**Flood Control Project Maintenance
Levee Inspections**

Maintenance Issue Types Only, Levee Inspection Report By Mile - Spring 2019

Reclamation District No. 2058 Pescadero

Waterway	Bank	Unit Miles	Inspection Start/End	Inspector
Unit No. 01 Paradise Cut	Left	6.58	05/06/2019 05/06/2019	Alberto De Leon

Photo 1 of 4 : SP_2019_RD2058_111_1_20190313_00001.jpg

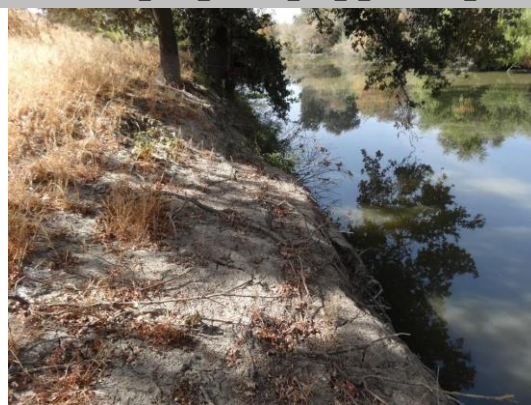
LM Start	4.43	Rating **	M	Issue No.	1
LM End	4.47	Issue Type +	Ma	Location *	WS
Category	Supplemental			GPS Latitude/Longitude	
				Start	End
Item	DWR Erosion Survey			37.789810 °	37.789653 °
				-121.352490 °	-121.351791 °
DWR ID	RD2058U01RM3.97

Comment Code					
Inspector Comment					
10/10/2017: No significant change observed.					
07/20/2016: No significant change observed.					
08/04/2015: No significant change observed.					
08/26/2014: No significant change observed.					
08/28/2013: No significant change observed.					
07/26/2012: The site has been visited, and no significant change has been observed.					
09/02/2011: This site was not visited due to the time limit.					
09/22/2010: No significant change observed. Minor pocket erosions are lined at the lower bank. Two large Oak and Willow trees are on mid-slope and bench. The remaining bench was re-measured and found to be approximately 10 feet. There was no indication of active erosion on site during the site visit.					
08/05/2010: Recommended for annual assessment and monitoring of the site during flood events, per CLRO.					
07/23/2009: No major change observed since last visit; site is a 200-ft. long near-vertical berm erosion; recommend annual assessment and monitoring of the erosion site, per CLRO CES Evaluation 2008 Report; Site # is the same site previously reported as RM4.0,LM4.51; previously rated "U".

09/10/2008: Two large trees (2-3' DBH) with partial roots exposed.					
2007: Visited site 03/13/2007. [2017 Site ID:RD2058U01RM3.97]

Direct view of the pocket erosion site.
